CITY OF WESTMINSTER			
PLANNING APPLICATIONS COMMITTEE	Date 10 March 2015	Classification For General Release	
Report of Operational Director Development Planning		Wards involved Hyde Park	
Subject of Report	7 Archery Close, London, W2 2BE		
Proposal	Erection of glazed openable roof to enclose rear garden at lower ground floor level.		
Agent	Turley		
On behalf of	c/o agent		
Registered Number	14/11604/FULL	TP / PP No	TP/25374
Date of Application	24.11.2014	Date amended/ completed	26.01.2015
Category of Application	Minor		
Historic Building Grade	Unlisted		
Conservation Area	Bayswater		
Development Plan Context - London Plan July 2011 - Westminster's City Plan: Strategic Policies 2013 - Unitary Development Plan (UDP) January 2007	Outside London Plan Central Activities Zone Outside Central Activities Zone		
Stress Area	Outside Stress Area		
Current Licensing Position	Not Applicable

7 ARCHERY CLOSE, W2

SECTION B-B

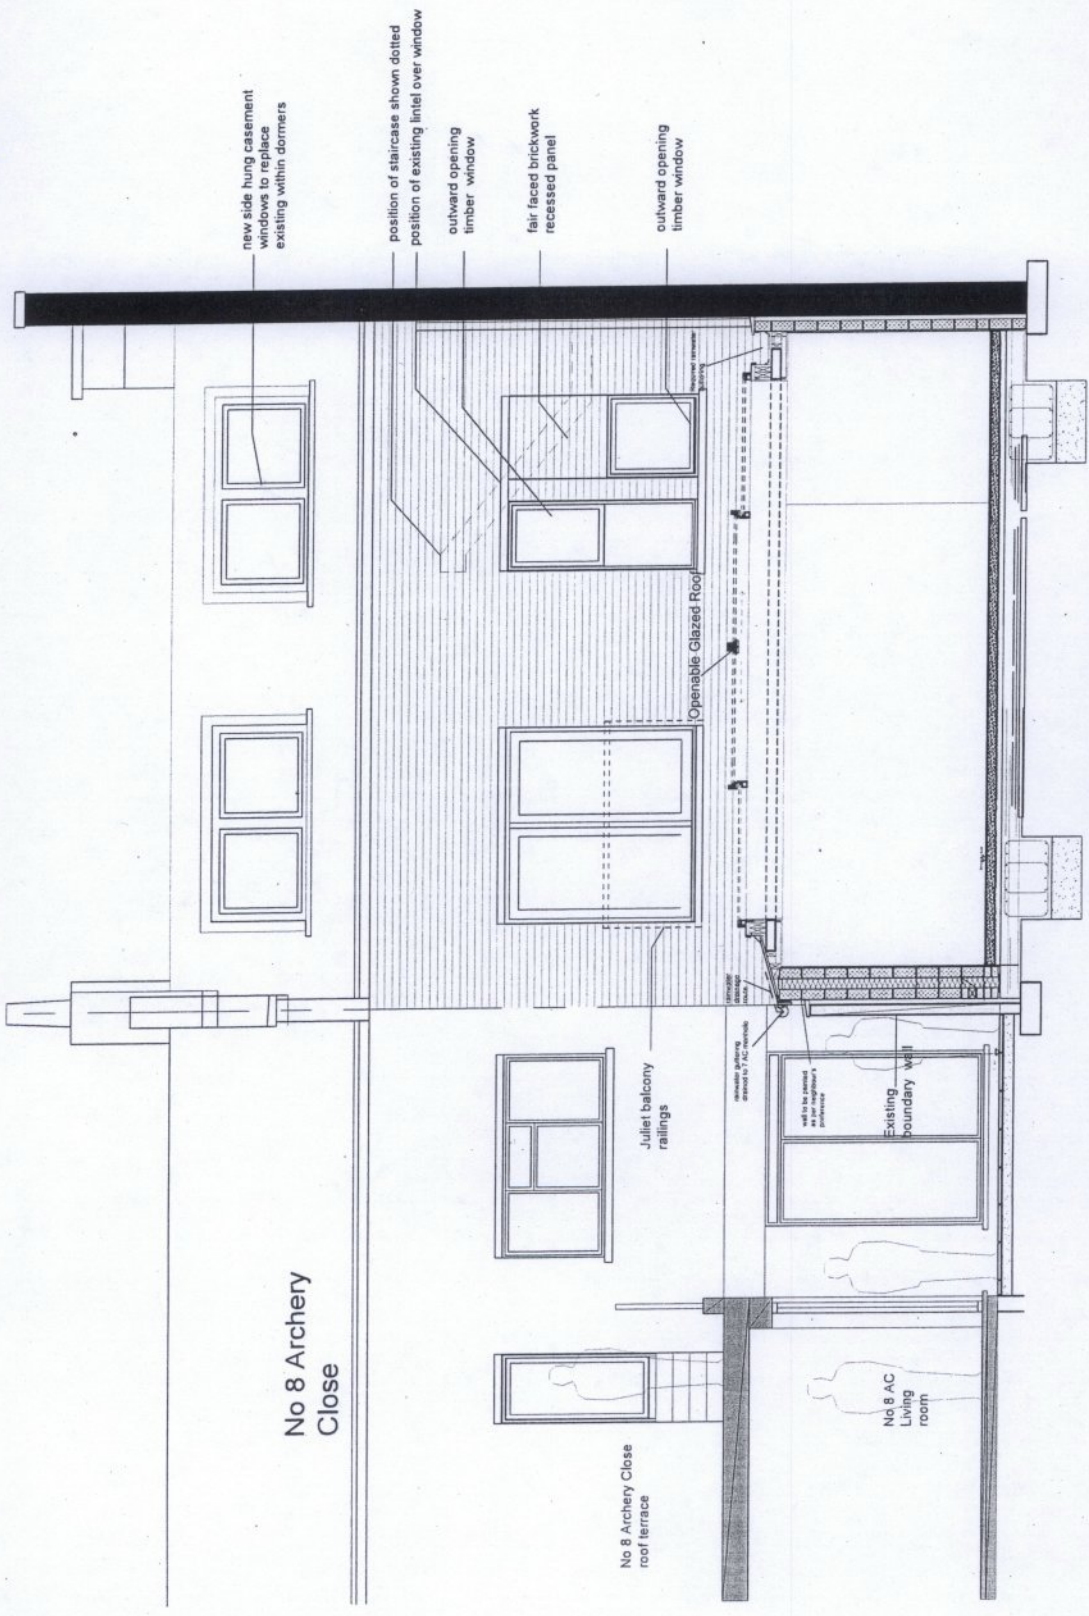
- Were not consulted on previous application.
- Drawings inaccurate, especially position of balcony handrail lintel and height of person standing on flat roof. Also show different heights in different drawings.
- Height should be measured from patio of No.8 as 7 Archery Close patio has been raised by 15cm.
- Title of application as "glass enclosure" wrong because no glass side panel and part solid roof.

The objectors pointed out in their response to the initial consultation that a number of inaccuracies were present on the submitted drawings including the position of the balcony handrail, French door lintel and height of person standing on the flat roof of No. 8. The applicant has since revised the drawings to correct these inaccuracies.

SIDE ELEVATION
(from No 8 Archery Close Patio)

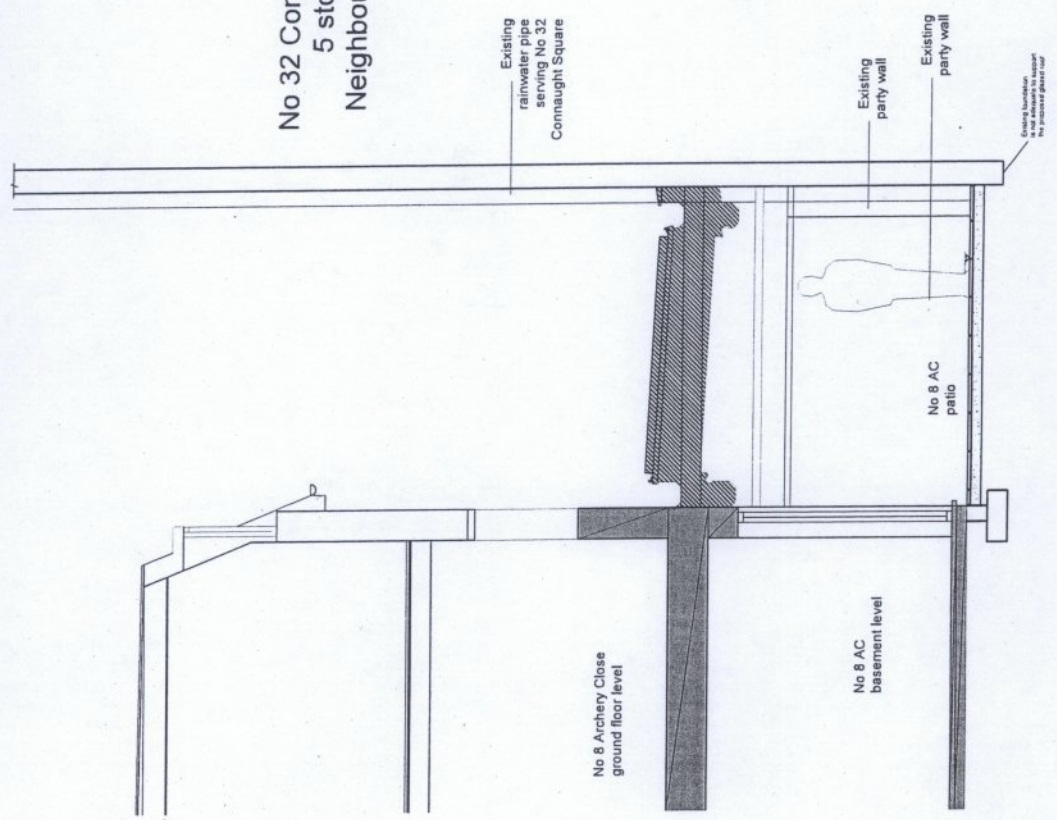
- Decrease in light - any height increase above 2.6m and not of glass construction should not be acceptable.

- Still a decrease in light as shown by 45 degree angle. State that any height above 2.6m will interfere with light to Archery Close and should not be acceptable as previously stated by the Planning department.
- Sense of enclosure created by solid nature of extension and side wall.
- Current planning application occupies 100% of curtilage of No.7 resulting in increased sense of enclosure to residents of No. 8.
- Also results in a lack of ability to drain rainwater within property boundary, repair and maintenance space.

The objector also states that any height above 2.6m and not of a glass construction will always interfere with light to Archery Close and should not be acceptable as previously stated by the Planning department. This appears to be referring to an extract of the officer's report for the September 2013 planning permission which merely stated that that proposal resulted in only a modest 2.6m height at the boundary wall and would not have a significant impact on the daylight and sunlight or sense of enclosure to No.8. It did not suggest that any increase beyond that would result in an unacceptable impact on the light to No.8. In any case the height of the enclosure at the boundary wall of the proposed scheme is less than 2.6m (approximately 2.1m when measured from the patio of No.8).
